Product Change Notification

1. ECR #: 207931
Notification #: 602

3. Series:
• ERF6 ASSEMBLY

4. Part #'s Affected
• ERF6-XX-03.5-X-DV-A-XX-K-XR

Old Design (.098 diameter K-Dot) vs New Design (.118 diameter K-Dot)

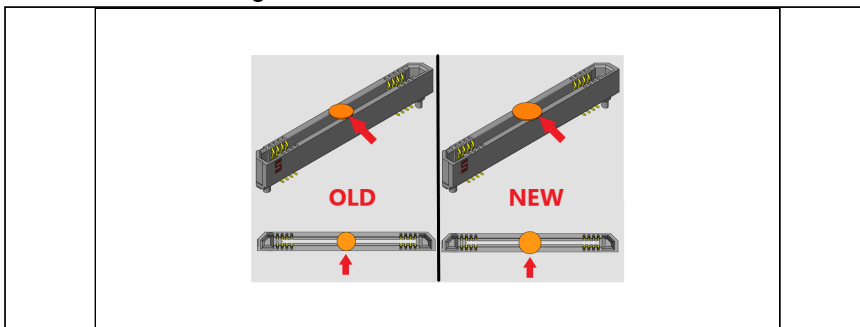
5. Description of Change:
ERF6 is being transferred to Samtec's vision inspection platform

6. Method of Identifying Change
K-Dot diameter changed from .098" to .118"

8. Impact of Change on Form, Fit, or Function:
• Form - Increased K-Dot size
